Window - Rear Quarter Window Failure

501-49

Rear [Quarter Window Regulator](#) Failure - Excessive Bracket Flex - Repair Procedure

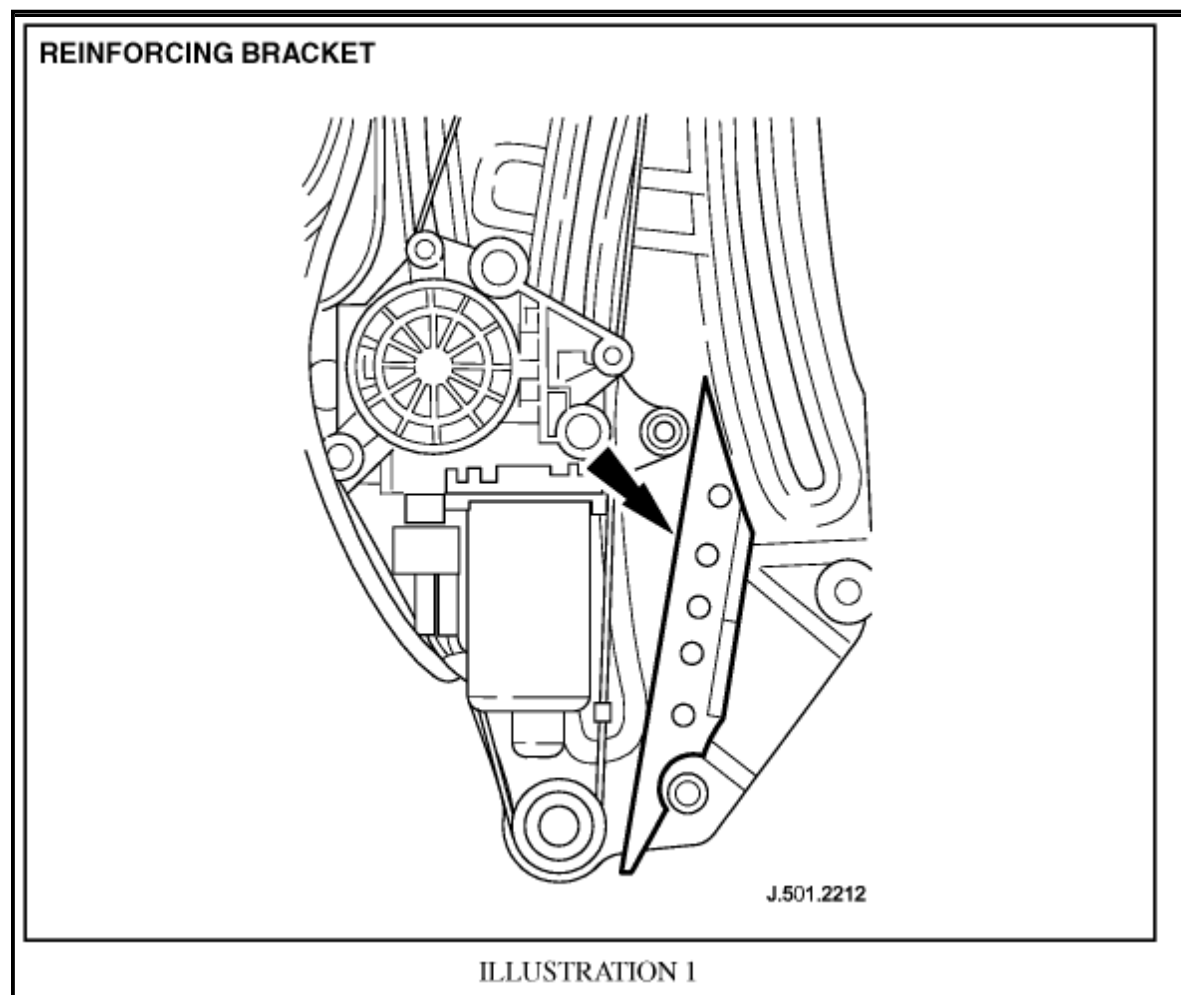
Some 1999-2000 MY XK convertibles, within the above VIN ranges, may experience customer complaints of failure of the regulator for the rear quarter window. It has been identified that the rear [quarter window regulator](#) assembly base plate may be made from a softer than normal metal. Although this material is within specification, it can lead to excessive flexing of the base plate, subsequently leading to the drive cable becoming detached. To eliminate this concern, a reinforcing bracket has been added to the bottom of the assembly to improve stability.

Note: If only one side rear [quarter window regulator](#) has failed, inspect the opposite regulator to see if it is equipped with a reinforcing bracket (Arrowed area in Illustration 1.) If not replace both regulators.

If a regulator fails, replace the assembly with the latest level regulator. The opposite side must also be checked for the latest level component and replaced if necessary.
